## SMALL CROSSBAR SWITCH REQUIREMENTS AND ADJUSTING PROCEDURES

- 1.001** This addendum supplements Section 030-721-701, Issue 5.
- 1.002** This addendum is issued to:
- Revise requirement in 2.11(f)(2) to add information concerning minimum working length of paddle wire.
  - Revise note following 2.11(g)(2) to provide additional instructions for preventing select wire flipping.
  - Change Figure 12 to identify outermost face of core.
  - Revise 3.001 to add tools and gauges to list.
  - Add 3.11(4)(c) concerning use of additional tools and gauges for checking the holding armature.

**ADDENDUM 030-721-701**

**Fig. 12—Method of Measuring Holding Armature Core Gap**

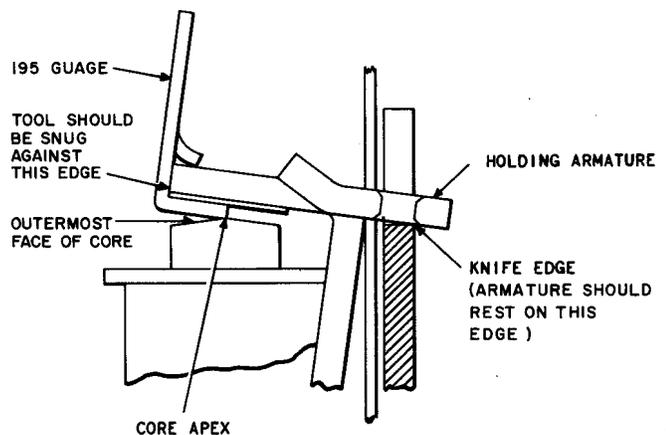
- 2.003** On Page 12, change Figure 12 to identify the location of the "Outermost Face of Core."
